Remarks

Upon entry of the foregoing amendment, claims 1-5, 7-13, 17-25, 29-35, and 37-43 are pending in the application, with 1, 7, 13, 17-19, 24, 30, 32, 37, 39, 41, and 43 being the independent claims. Claims 1, 5, 7, 8, 11, 12, 13, 17-19, 24, 25, 29, 30, 32, 37, 39, and 41-43 are sought to be amended. These changes are believed to introduce no new matter, and their entry is respectfully requested.

FIG. 13A

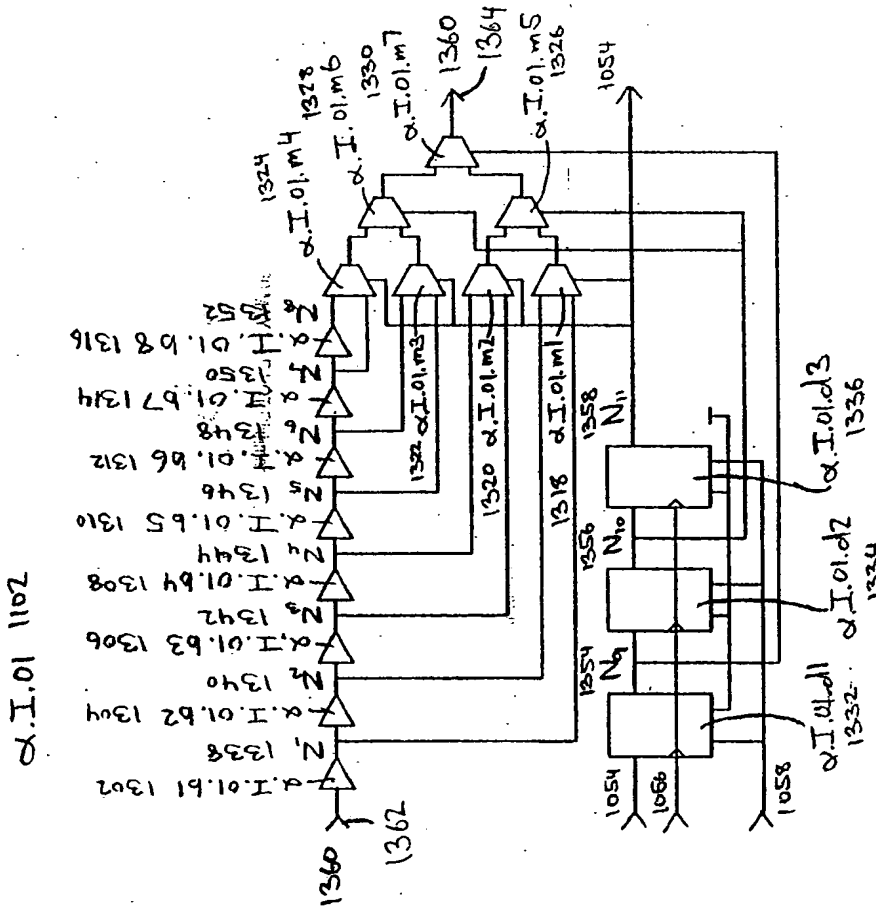
as failing to comply with the enablement requirement. The claim(s) contains subject matter which was not described in the specification in such a way as to enable one skilled in the art to which it pertains, or with which it is most nearly connected, to make and/or use the invention. The subject claims recite here in part ". . . delay buffers to be configured one of to convey said first bit through said delay buffer and to bypass said first bit around said delay buffer". The language is vague and confusing, it is not clear from the specification or

drawings whether the "first bit" is being conveyed or bypassed. Appropriate correction is required.

Amendments to Figure 13A

Applicants have amended Figure 13A, a schematic diagram of an embodiment of pad delay circuit α .I.01 1102, to add reference label "1362" for the input and reference label "1364" for the output. Support for these amendments can be found, *inter alia*, at paragraph [0138] of the specification.

For example, in amended FIG. 13A, each of delay buffers α .I.01.b2 1304, α .I.01.b3 1306, α .I.01.b4 1308, α .I.01.b5 1310, α .I.01.b6 1312, α .I.01.b7 1314, and α .I.01.b8 1316 is

configured both to convey bit 1360 through the delay buffer and to bypass bit 1360 around the delay buffer as recited in claim 10.

Also, for example, in amended FIG. 13A, multiplexers $\alpha.I.01.m1$ 1318, $\alpha.I.01.m2$ 1320, $\alpha.I.01.m3$ 1322, $\alpha.I.01.m4$ 1324, $\alpha.I.01.m5$ 1326, $\alpha.I.01.m6$ 1328, and $\alpha.I.01.m7$ 1330, and delay flip-flops $\alpha.I.01.d1$ 1332, $\alpha.I.01.d2$ 1334, and $\alpha.I.01.d3$ 1336 comprise a control circuit configured to align delay buffers $\alpha.I.01.b2$ 1304, $\alpha.I.01.b3$ 1306, $\alpha.I.01.b4$ 1308, $\alpha.I.01.b5$ 1310, $\alpha.I.01.b6$ 1312, $\alpha.I.01.b7$ 1314, and $\alpha.I.01.b8$ 1316 to convey bit 1360 through a delay buffer or to bypass bit 1360 around a delay buffer as recited in claim 11.
